WSU Indigenous Centre of Excellence

TTW-CIV-CAN-002 – Turf Cell Installation and Maintenance Strategy & Responses to NSW Heritage

Figure 1. Turf Cell Installation Details

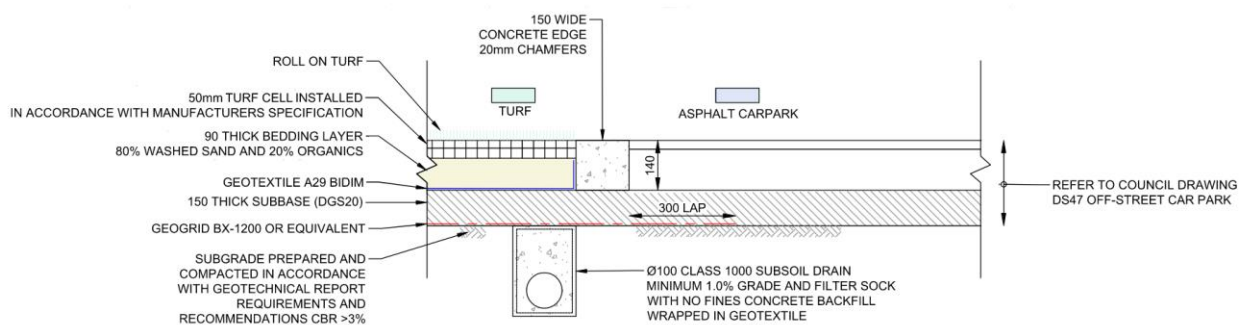
The turf cell systems are proposed for use in parking bays only. Areas subject to frequent vehicle movements, including driveways and traffic aisles, are more susceptible to wear that can damage the turf and lead to loss of grass cover. Accordingly, conventional asphalt pavement is proposed for driveways and traffic aisles within the car parks. This approach is supported by correspondence with turf cell suppliers, as provided in the attachments.

The turf cell installation detail is shown in Figure 1 below.
